Subject: SHEARON HARRIS NUCLEAR POWER PLANT, UNIT NO. 1  
DOCKET NO. 50-400 / LICENSE NO. NPF-63

LICENSE RENEWAL APPLICATION, AMENDMENT 2: CHANGES  
RESULTING FROM RESPONSES TO SITE AUDIT QUESTIONS  
REGARDING TIME-LIMITED AGING ANALYSES

## Harris Nuclear Plant License Renewal Audit Question and Response Database

Figure 1 - RHR Transient Temperature and Stress Response for Branch Component

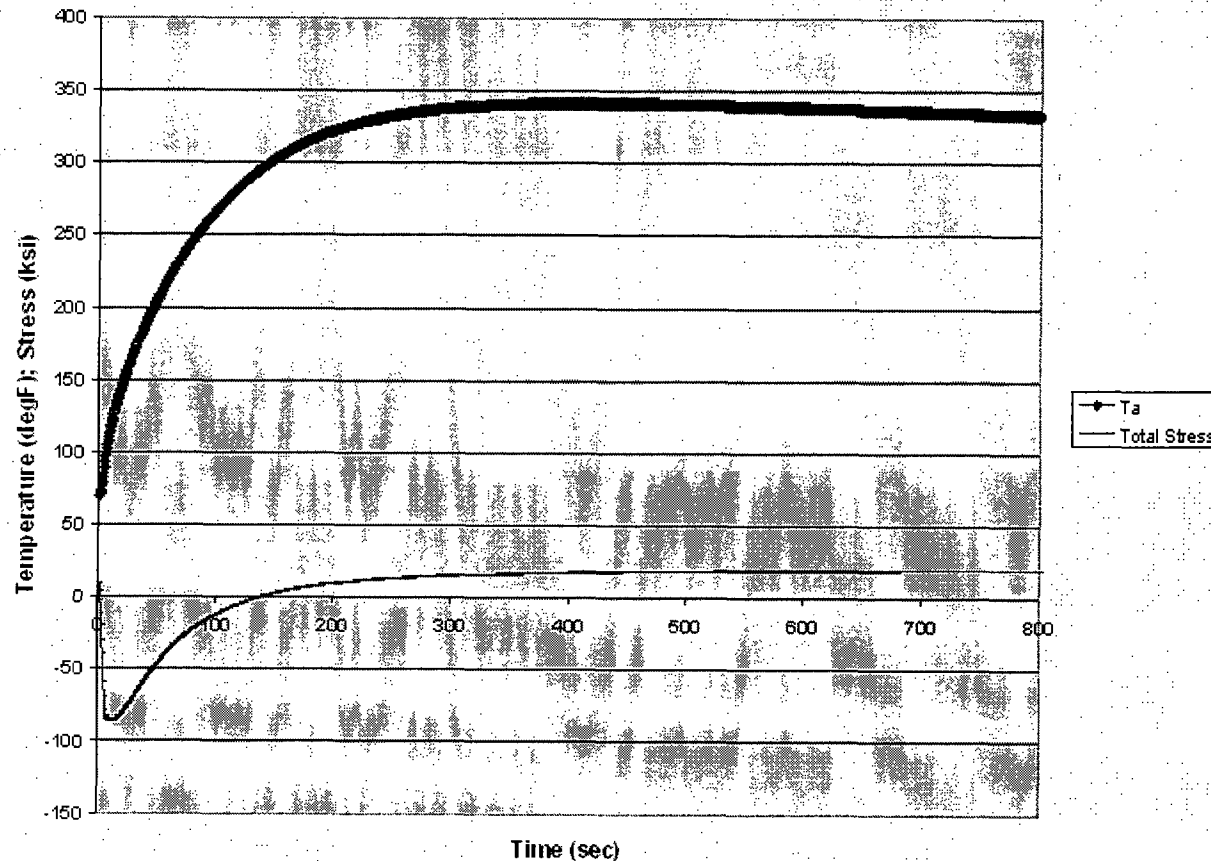
To address the question regarding the effect of the pressure and moment stresses on the total stress and resulting  $F_{en}$ , a detailed time history of the stress during the full RHR transient cycle was developed for the 12" x 1" branch component. The stresses were calculated consistent with the HNP design basis inputs and NB-3600 evaluation methodology. Applicable thermal transient, moment, and pressure histories were applied representing the RHR system design transient in the section of the RHR line containing the branch connection. The transient temperature goes from ambient conditions, at 70°F, to 350°F simulating the initiation of RHR flow through the otherwise isolated section of piping. The design transient description also assumes after the transient that gradual cooling of the system occurs at 100°F/hr, which was considered to represent negligible stress in the design. The RHR flow is initiated by design at approximately 425 psig system pressure. Therefore, a pressure load of 450 psia was used in the calculation. The moment stress from the piping design analysis of the branch was realistically ramped over the transient as a function of the pipe temperature. Pressure and moment stresses were considered only as tensile. The thermal stresses were appropriately signed to represent the inside wall stress in response to the thermal transient. The stresses were adjusted with the branch stress indices consistent with the Code analysis. The resulting stress history is illustrated in Figure 1.

This demonstrates that for the significant part of the transient history, the component is in the compressive state on the inside surface where environmental effects may be applicable. For this reason, in the initial estimation of environmental effects on this component, it was judged that environmental effect would be small and  $F_{en} = 1.0$  was applied. However,

This should be applied to the usage calculated from the stress pair formed from the stress peaks represented by the minimum stress state (maximum compression) and the maximum stress state (maximum tension) of the transient. The total stress range in Figure 1 is approximately 102 ksi. Using the ASME design fatigue curve for stainless steels, this corresponds to approximately 1680 allowable cycles. For 200 design cycles of the RHR transient, the usage factor is 0.12. Applying  $F_{en} = 1.15$ ,  $U_{en} = U * F_{en} = 0.13$ .

**Figure B-1: Benchmark Transient.**

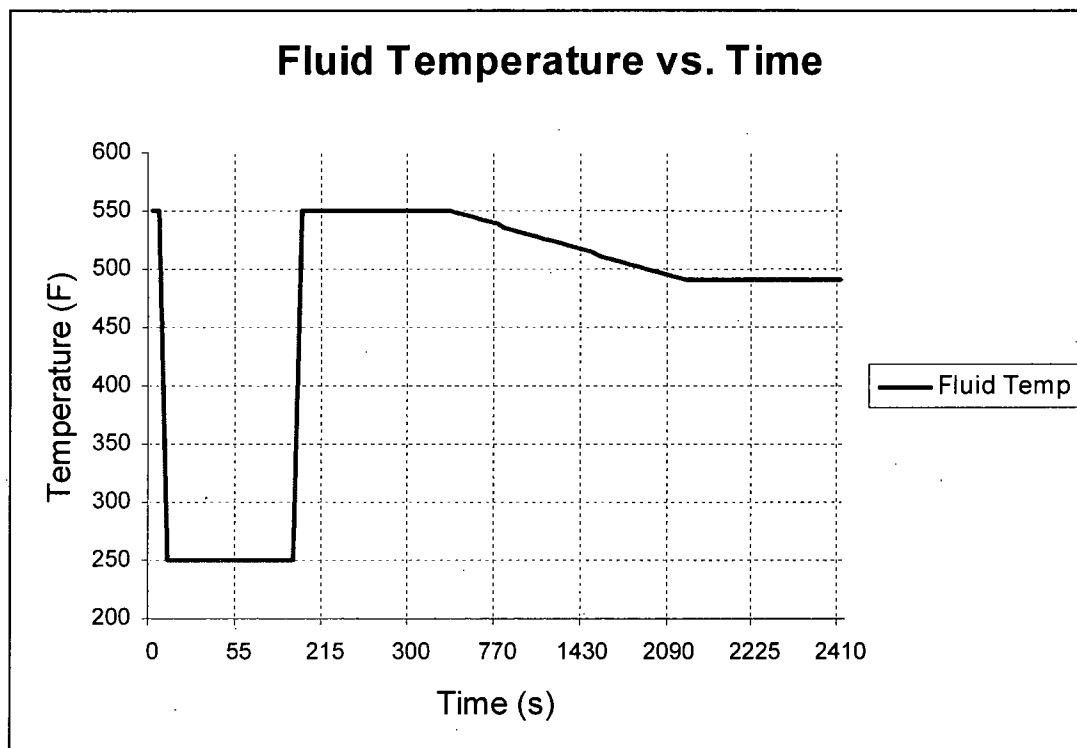
To benchmark and verify this portion of the database and determine the appropriate scaling factor for the thermal loads, an arbitrary transient was used. The transient used for this benchmarking problem is defined in the data shown in Table B-6 and Figure B-1.

In this benchmarking transient, Zone 1, Zone 2, and Zone 3 undergo a severe thermal shock. The transient considered is hypothetical but is intentionally made severe on the temperature rate so as to allow a vigorous examination of the integrity of the transfer function database. The transient is shown in the Figure B-1. This transient was analyzed by both WESTEMS™ and ANSYS. Note that the ANSYS results represent full finite element analyses whereas the WESTEMS™ results are produced by the transfer function method, which utilizes the transfer function databases produced by ANSYS.
